**PLANNING AND DEVELOPMENT SERVICES STAFF REPORT**

**For Planning Commission Meeting of December 02, 2014**

**SUBJECT: 2250 Ann Arbor-Saline Road Zoning and Site Plan for City Council Approval  
(2250 Ann Arbor-Saline Road)  
File Nos. A14-003, Z14-017 & SP14-023**

**2250 ANN ARBOR-SALINE ROAD**  
 SITE PLAN  
 DIMENSIONAL SITE PLAN

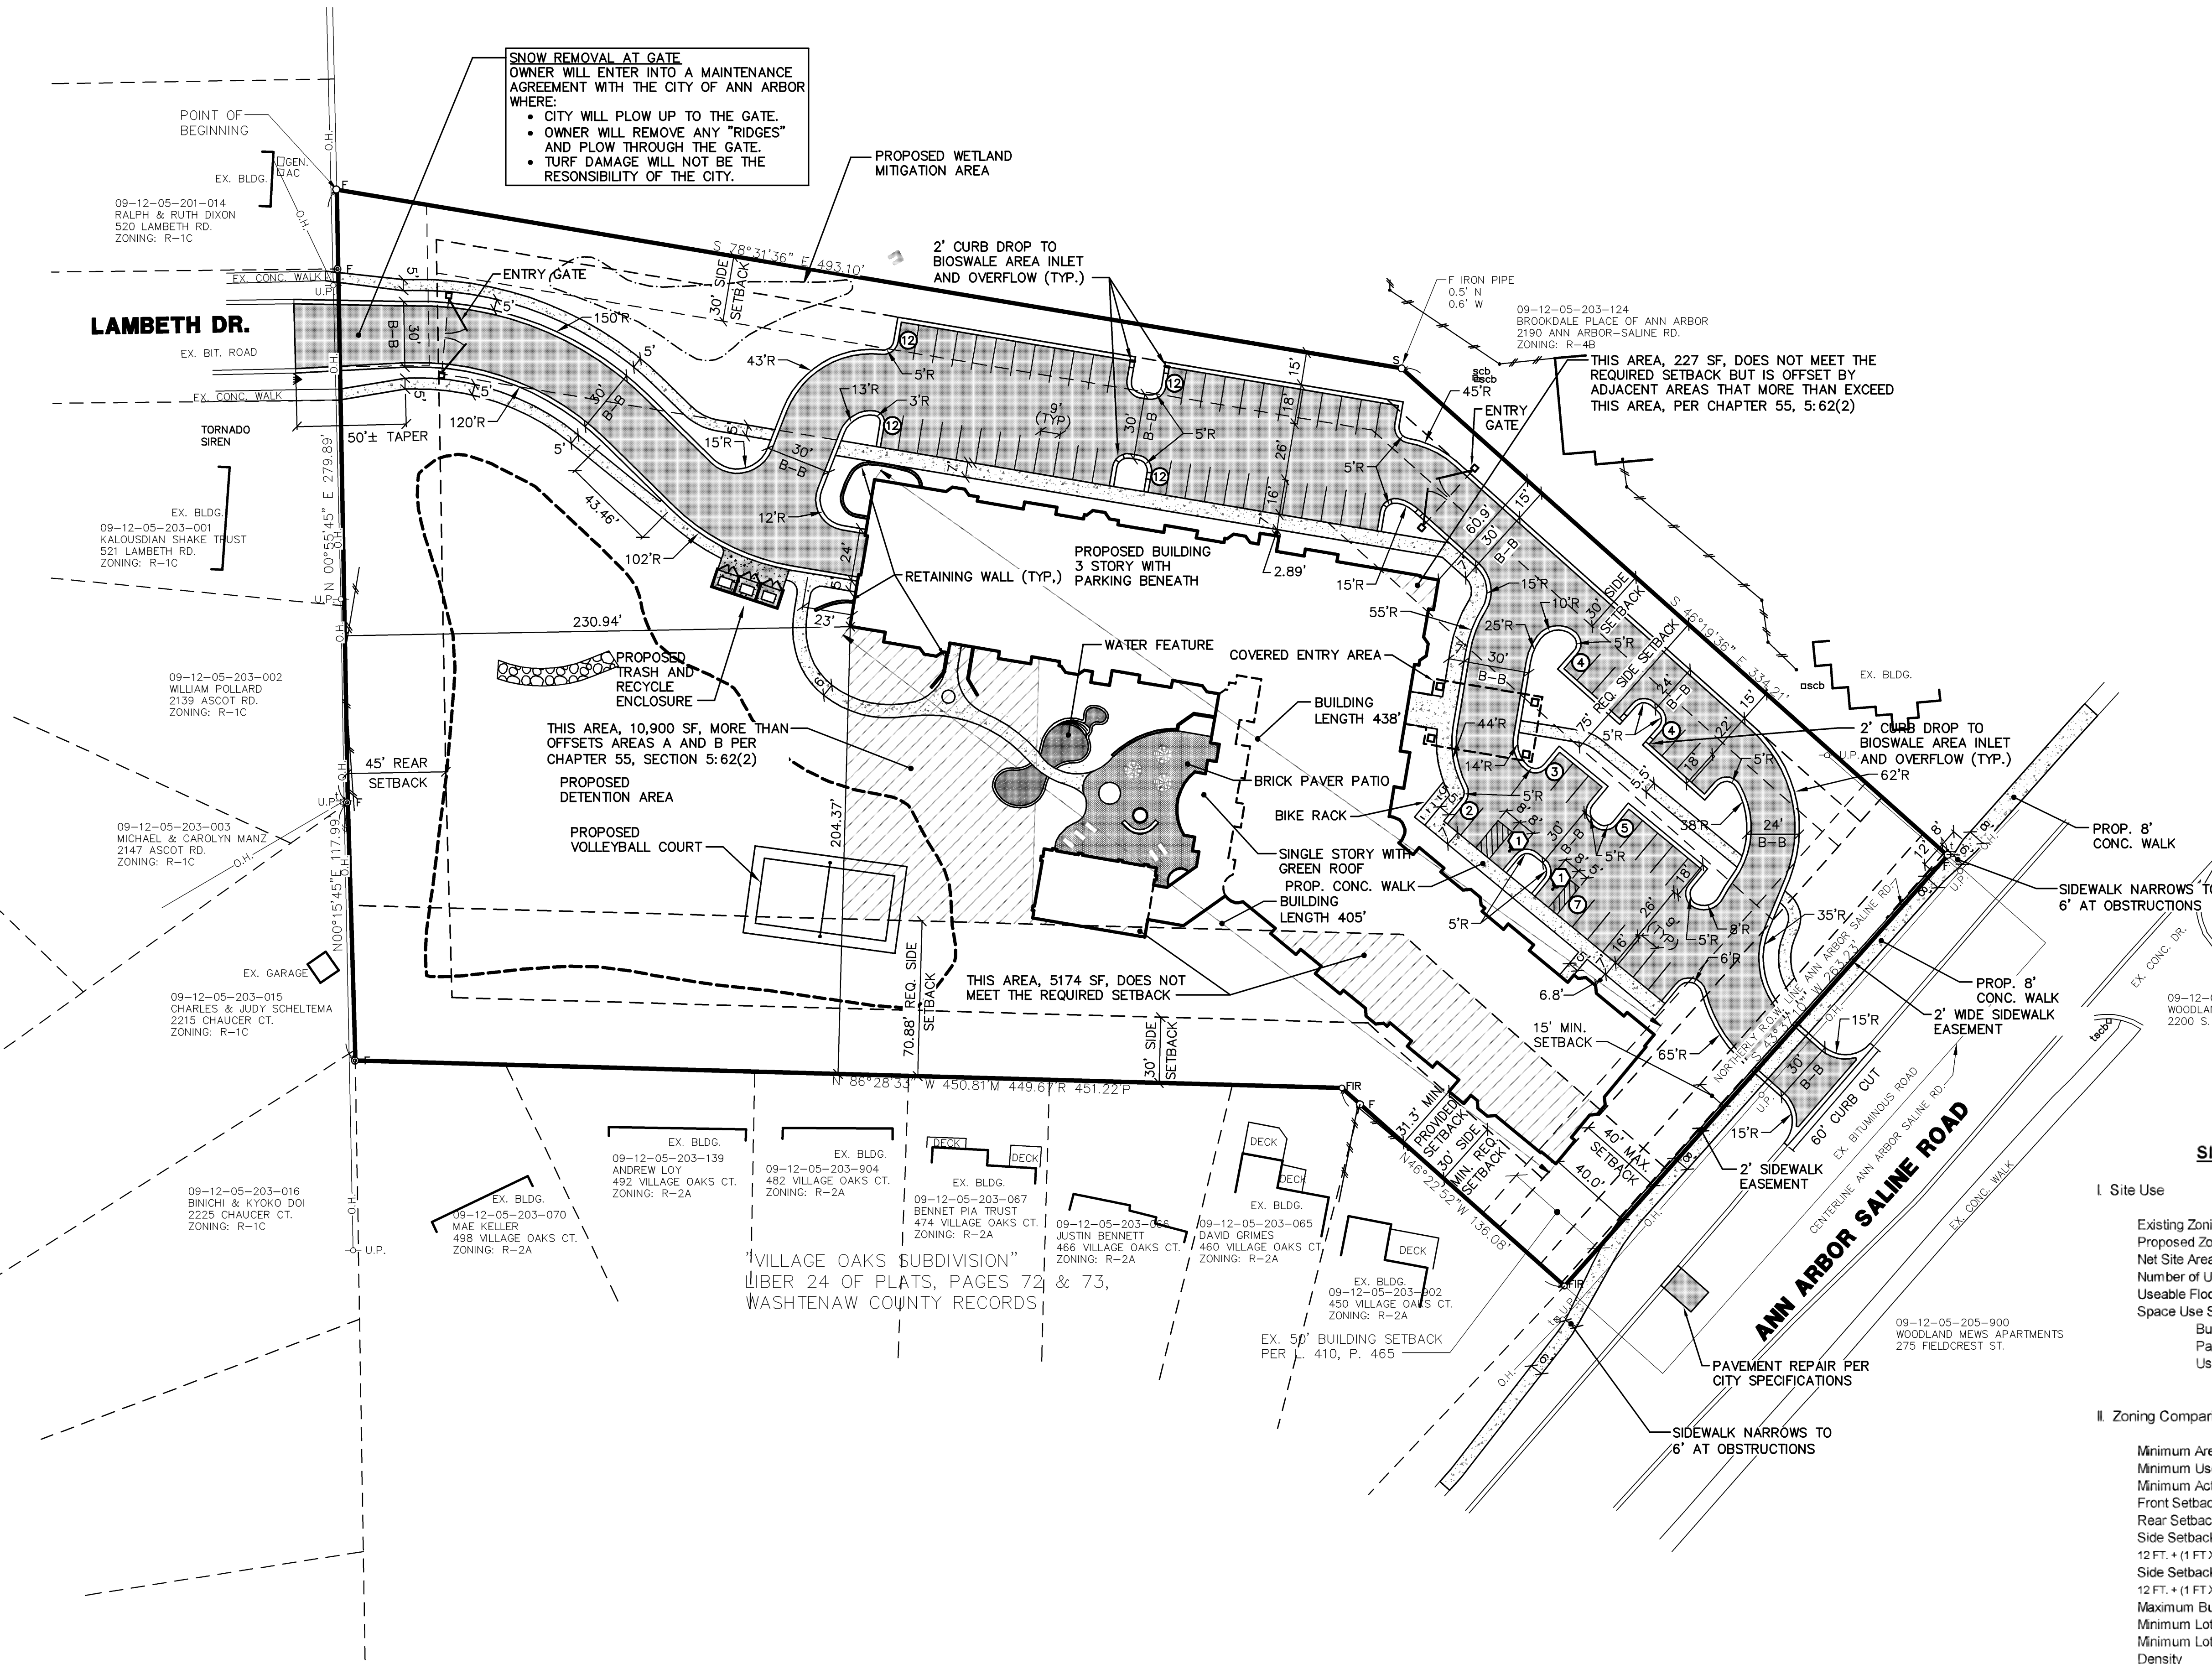
The site plan as submitted does not have general purpose connection to Lambeth, only a gated emergency and resident access point. Traffic Engineering staff supports a general purpose connection as it would benefit the public providing for improved neighborhood connectivity, a reduction in vehicle-miles travelled, improved emergency response times, and improved routing for snow plowing and trash pickup.

Fire – Fire hydrant coverage is being met, an additional hydrant will be installed on the site. The Fire Marshall supports the gated connection to Lambeth Drive for secondary access to the site. While the connection is not required because the project is less than 100 units, it is preferred to have multiple access routes available when it is possible to install them.
